**MOKIHINUI HYDRO PROPOSAL  
CONSENT APPLICATIONS  
REVIEW OF ASSESSMENT OF ARCHAEOLOGY, CULTURAL  
AND HISTORIC EFFECTS**

**JULY 2008**

Prepared by:  
Chris Jacomb  
*Southern Pacific Archaeological Research*  
Department of Anthropology  
University of Otago  
Dunedin

Figure 1. SO 11202 (date unknown) showing "pack track" terminating near Seatonville.

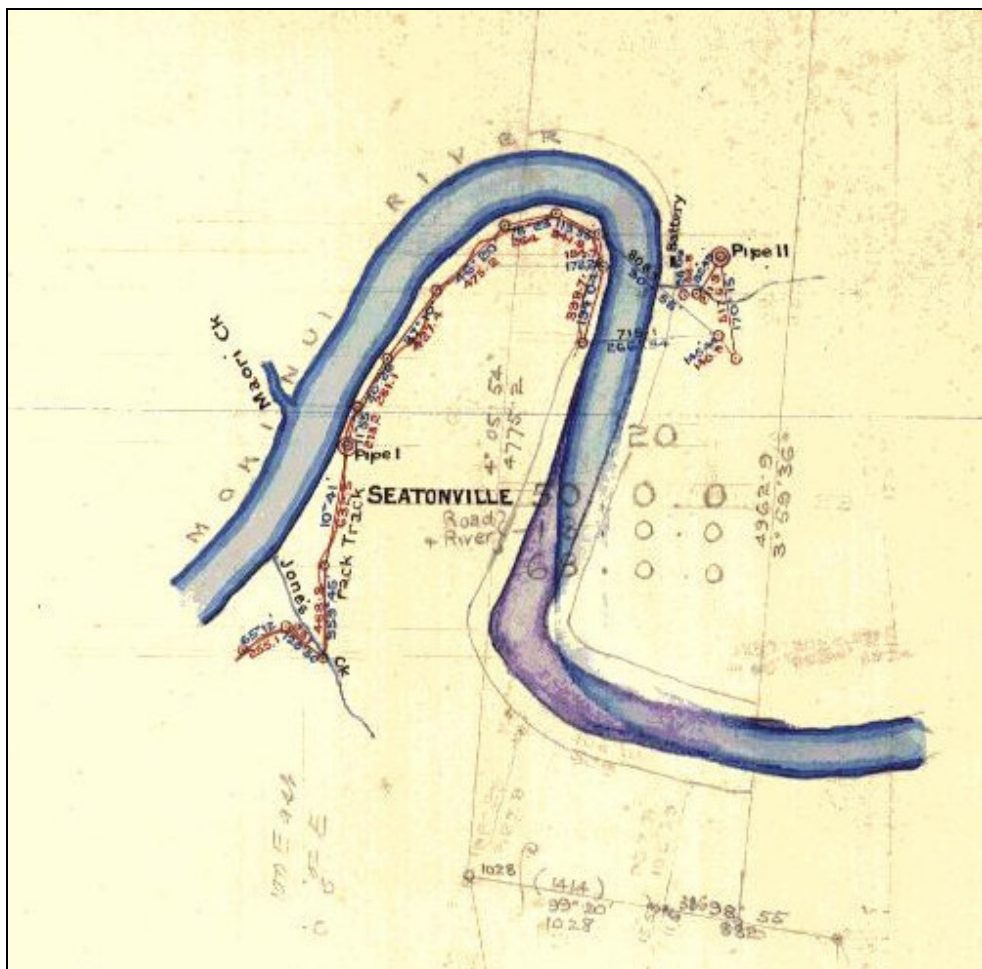
Although little historical research has been undertaken on the pack track, it appears to have three phases of historical activity that contribute to its significance. The first is the stretch from the dam site to Seatonville (between Jones Ck and Specimen Ck) the construction of which began some time after 1867 and which had been completed as far as Coal Creek (about 1 km east of Seddonville) by 1874 (Barr 2007: 13-14). It appears that the first application for a mining license in the vicinity of Seatonville was made in 1873 (Barr 2007: 14) at which time the mine warden noted that, although the ground was rough, a track could be made there. I have done no research myself into the history of the pack track but it seems unlikely that the track would have been formed any further upstream than necessary to service the gold mining operation. Some support for this can be seen in an early but apparently undated survey plan, SO 11202 (Barr: fig. 6, see Figure 1 below). This plan shows a surveyed line labelled "Pack Track" that originates downstream from Seatonville and terminates at the upstream extent of the known historical remains in the Mokihinui Gorge. I will call this Phase 1.

At some time a route was formed to Karamea via the Rough and Tumble Creek. The Iron Bridge was constructed over the Mokihinui River at the confluence to provide access some time around the turn of the century. This use of the track was slightly different from that to Seatonville and may have been intended for wheeled vehicles. I will call this Phase 2, although I am not certain of the chronological relationship with Phase 1.

Finally, there was a less formal track formed up to the Forks. I will call this Phase 3. It may in fact be better described as a "route" and is currently very difficult to follow in places.

According to this information, it is likely that only the stretch of track between the proposed dam site and Seatonville is especially significant historically. According to Mark Pickering's submission and an anecdotal report, this section is in much better condition than is indicated in the Consultant's report. The section from the dam site to the old iron bridge has added importance arising from its dual role in being part the Rough and Tumble Creek track.
